PREVOST

WARRANTY BULLETIN

WB16-02H

DATE :	MAY 2016	SECTION :	06 - Electrical
EXPIRATION:	MAY 2018		
SUBJECT :	CHARGING SYSTEM IMPROVEMENT

FIGURE 9

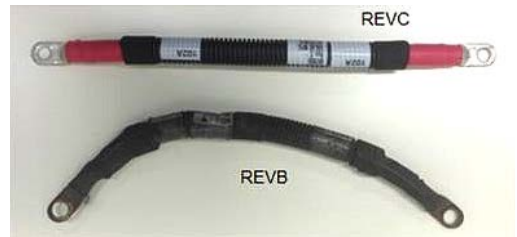
7. Reinstall the jumper cable **#067835 revision C** included in kit #7770335 (FIGURE 7, FIGURE 8).

Rev.C lug terminal through hole dia.= 5/16" CORRECT

Rev.B lug terminal through hole dia.= 13/32" INCORRECT

Rev.B diameter of the through hole is too large, reducing contact surface with the stud and the nut thus reducing electrical conductivity between the lug and the alternator stud (FIGURE 9).

FIGURE 10

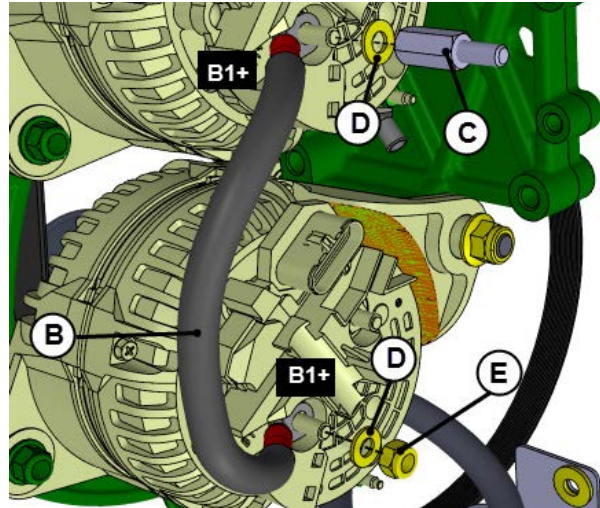
-
8. Reinstall appropriate jumper cable **B** (i.e. rev.C) with appropriate stud adapter. Refer to **FIGURE 10**.

Note: M8 nut "E" formerly #5001787 is canceled. Use nut #5001983 instead.

- B : JUMPER CABLE #067835 revision C**
C : STUD ADAPTER #060297 torque: 10 lbf-ft
D: FLAT WASHER #5001341
E: NUT M8 #5001983 torque: 10 lbf-ft

FIGURE 11

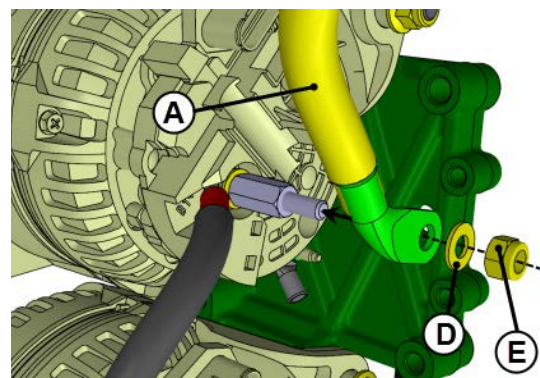
-
9. Reinstall power cable **A**. To do so, connect power cable **A** to the upper alternator **B1+** stud terminal. Refer to **FIGURE 11**.

Note: M8 nut "E" formerly #5001787 is canceled. Use nut #5001983 instead.

- A : POWER CABLE**
D: FLAT WASHER #5001341
E: NUT M8 #5001983 torque: 10 lbf-ft

FIGURE 13

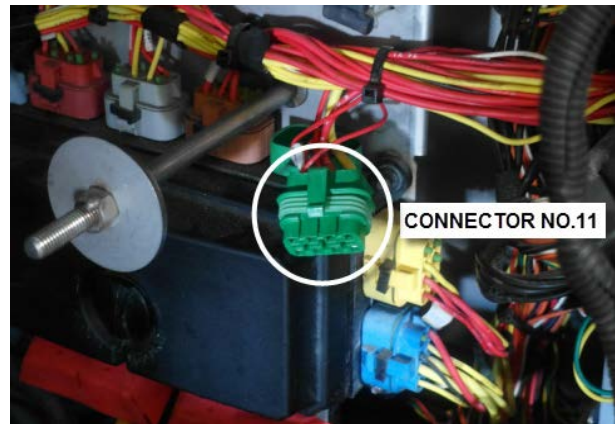
3. Using an extractor tool or a small flat blade screwdriver, remove wire 24VDALT from cavity H of connector no.11 (FIGURE 13 to FIGURE 16).

FIGURE 18 : WIRING DIAGRAM PAGE 5.1

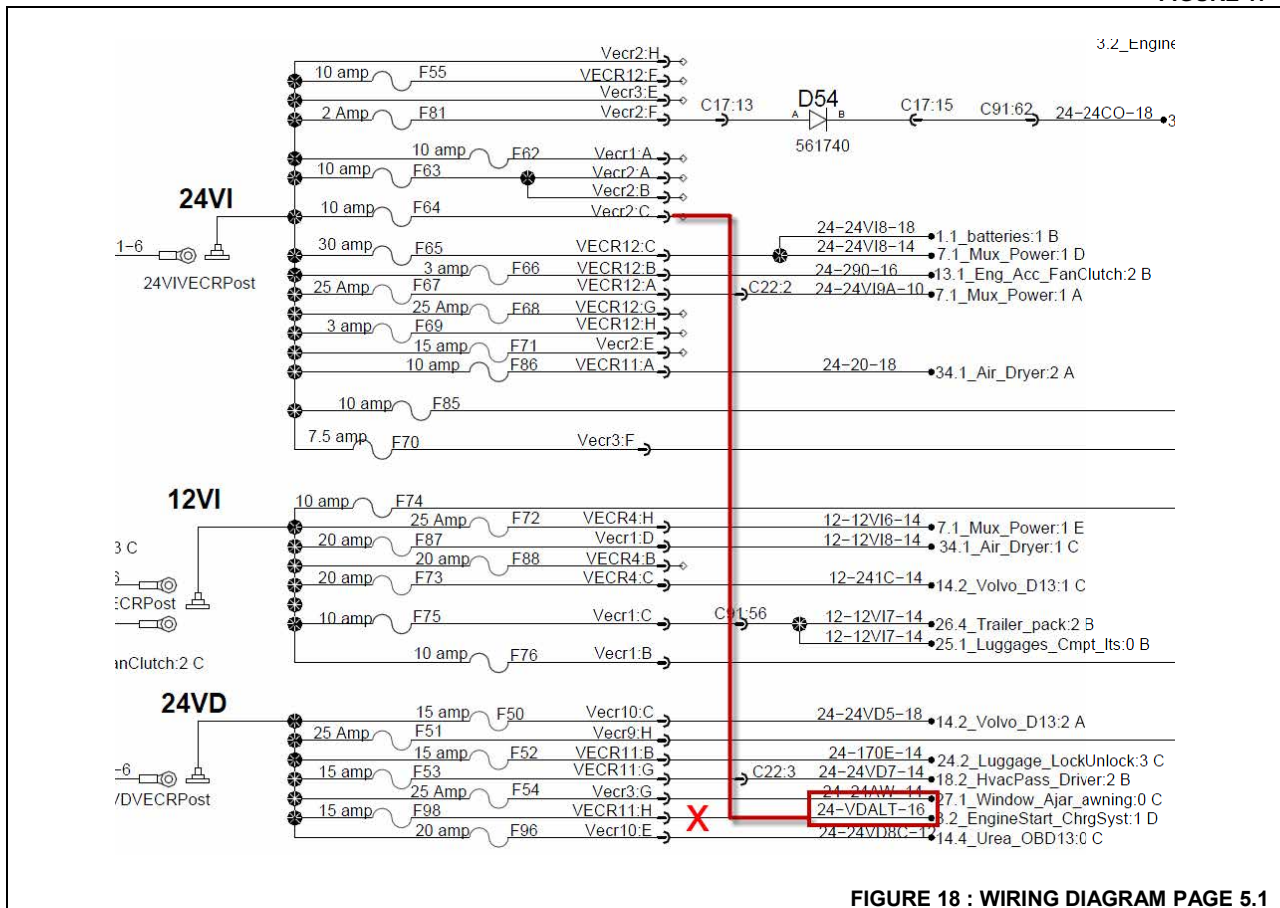
4. Relocate wire 24VDALT to cavity **C** of connector no.2 (red) on the harness.

Cavity **C** of connector no.2 should be available. This branch of the circuit will be protected by 10A fuse F64 (see FIGURE 18 below).

Should cavity **C** not be available, refer to your vehicle wiring diagram page 5.1 to select another free cavity protected by a **10A or 15A fuse** (see FIGURE 18 for reference).
